Olympus Reference: FY25-089-F-1 Removal of SOLTIVE™ Fiber Products

URGENT FIELD SAFETY NOTICE UPDATE

RE: SOLTIVE™ Laser Fiber Products (See Appendix 1 – Affected Products List)
Attention: Operating Room / Surgery and Risk Management Departments

Figure 1. Image showing the components of a SOLTIVE laser fiber device.

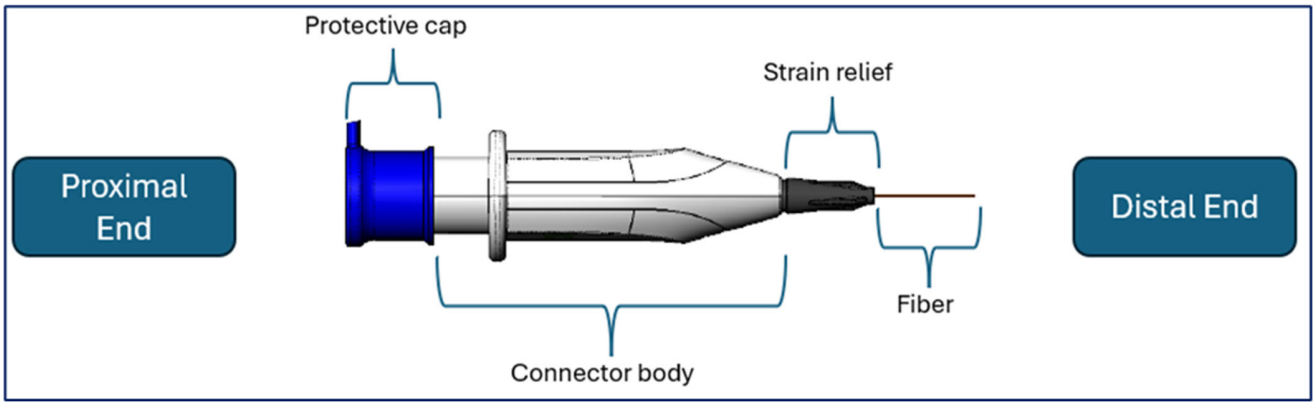
Olympus is initiating a Product Removal for the SOLTIVE SuperPulsed laser fiber products listed in the Appendix 1 of this letter. New versions of these devices are being introduced that use a new material for the strain relief component (see Figure 1). These products along with either the SOLTIVE Pro or SOLTIVE Premium laser generator consoles and their accessories (footswitch, interlock connector, etc.) make up the SOLTIVE laser system, which is intended for use in incision, excision, resection, ablation, coagulation, hemostasis, and vaporization of soft tissue, with or without an endoscope, in the following indications: urology, lithotripsy, gastroenterological surgery and gynecological surgery.

Olympus identified and is implementing an alternate material for the strain relief component that will more immediately self-extinguish if it were to ignite. Olympus is requesting users transition to products incorporating the new strain relief material and return all existing unopened and unexpired SOLTIVE laser fiber products.
